**ADDENDUM # 3**

**RFB-322-R  
RE-BID ELEVATOR MODERNIZATION  
CENTERTOWN PARKING GARAGE**

## SECTION 009113.3 – ADDENDA NO. 3

- A. Project Name: Elevator Modernization Centertown Parking Garage. Re-Bid.
- B. Owner: City of Elmira.
- C. Architect: Foor & Associates, Architects.
- D. Architect Project Number: 4062.
- E. Date of Addendum: June 16, 2026

JOB NO. 4062  
DWG. NO. M1.0

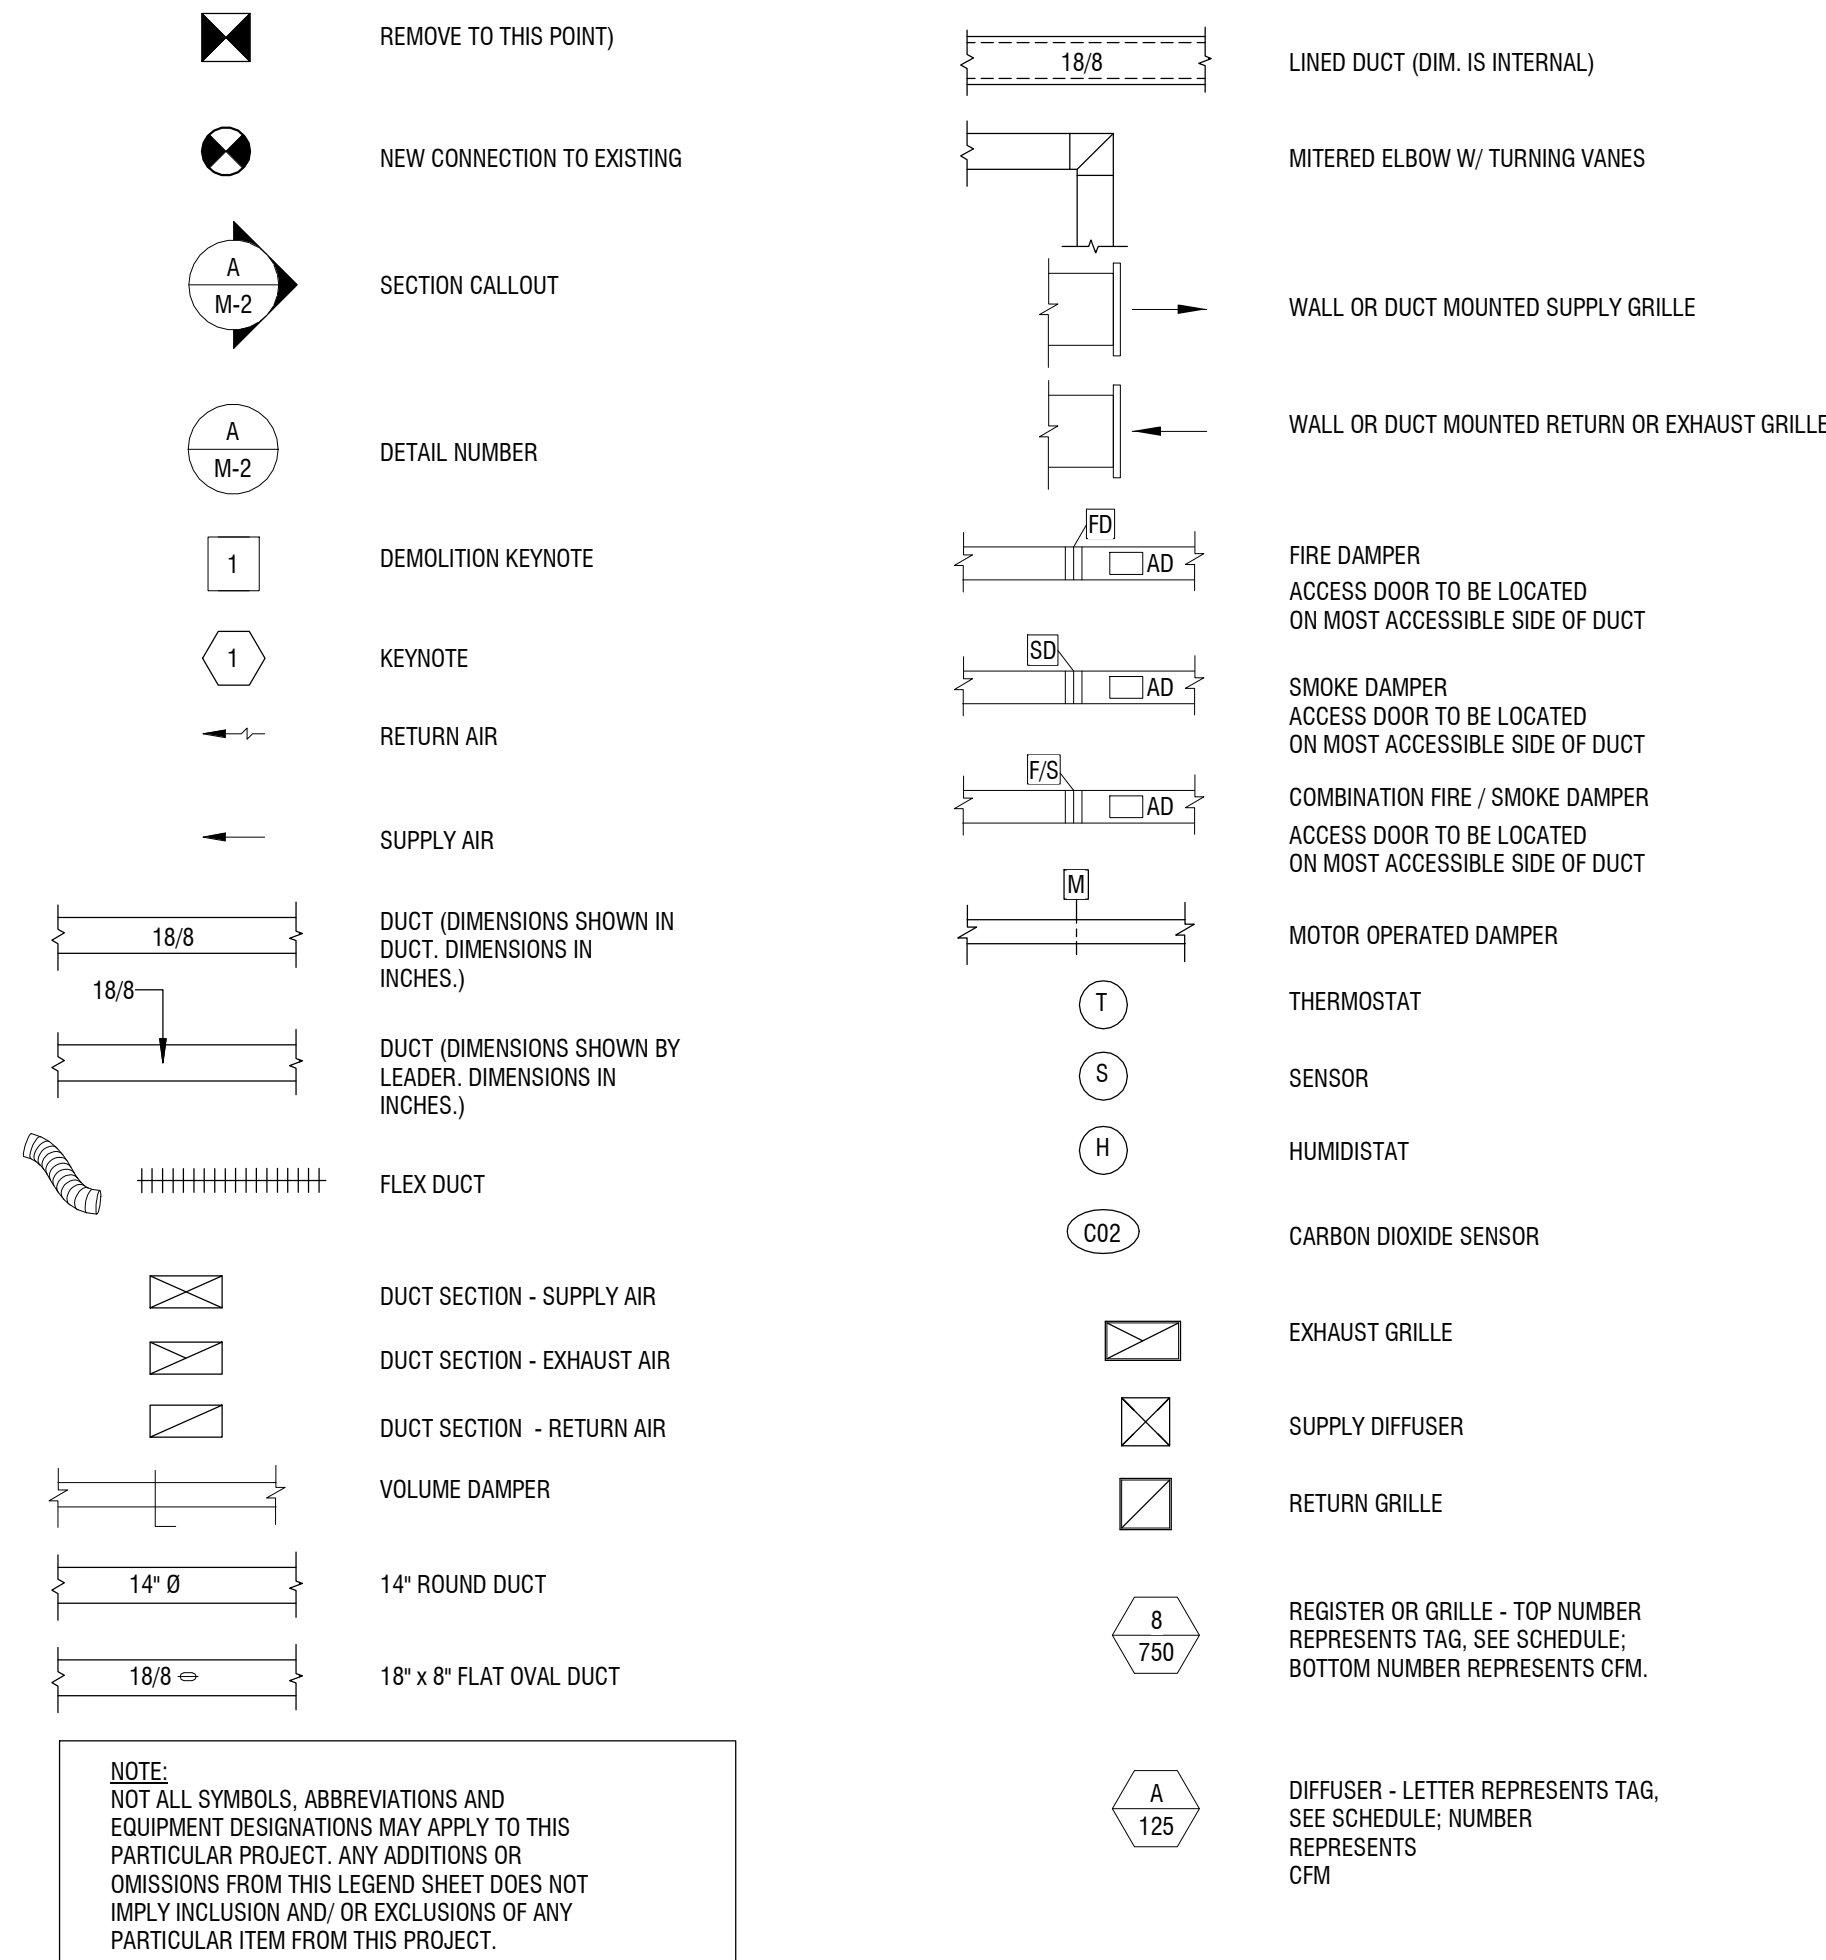
DRAWING #: M1.0

Per Duct Note 3 we are to provide coordination drawings - please confirm these are required for this project

Per Duct Note 9 - insulation is per Code - please provide specification for duct insulation

Per Pipe Note 1 - coordination drawings are to be provided - please confirm these are required for this project

Per Pipe Note 5 - insulation is per Code - please provide specification for insulation on refrigeration pipe

Are there existing "controls" on this project? If so please advise what system is being used.

Is testing and Balancing of new work required? Please provide specifications if needed.

**COORDINATION DRAWINGS ARE REQUIRED FOR THIS PROJECT. SEE ADDENDUM 1 FOR  
DUCT AND REFRIGERATION PIPING INSULATION SPEC.**

THERE ARE NO EXISTING CONTROLS ON THIS PROJECT. TESTING AND BALANCING OF NEW WORK IS REQUIRED, SEE ADDENDUM 1 FOR SPECIFICATION.

- I. DUCT INSULATION:**
- A. EXPOSED, ROUND AND FLAT-OVAL, SUPPLY-AIR DUCT INSULATION SHALL BE THE FOLLOWING:
- MINERAL-FIBER BOARD: 4 INCHES THICK AND 3-LB/CU. FT. NOMINAL DENSITY.

- V. TESTING:**
- TEST, ADJUST AND BALANCE HVAC AIR SYSTEMS AND COMPONENTS, TO AIR VOLUMES AND/OR PRESSURES INDICATED.
  - PREPARE REPORT OF TEST RESULTS, INCLUDING INSTRUMENTATION CALIBRATION REPORTS, IN FORMAT RECOMMENDED BY APPLICABLE STANDARDS.
  - PATCH HOLES IN INCULCATION, DUCTWORK AND HOUSINGS, WHICH HAVE BEEN CUT OR DRILLED FOR TEST PURPOSES, IN MANNER RECOMMENDED BY ORIGINAL INSTALLER.
  - MARK EQUIPMENT SETTINGS, INCLUDING DAMPER CONTROL POSITIONS, VALVE INDICATORS, FAN SPEED CONTROL LEVES, AND SIMILAR CONTROLS DEVICES, TO SHOW FINAL SETTINGS AT COMPLETION OF TAB WORK. PROVIDE MARKINGS WITH PAINT OR OTHER SUITABLE PERMANENT IDENTIFICATION MATERIALS.
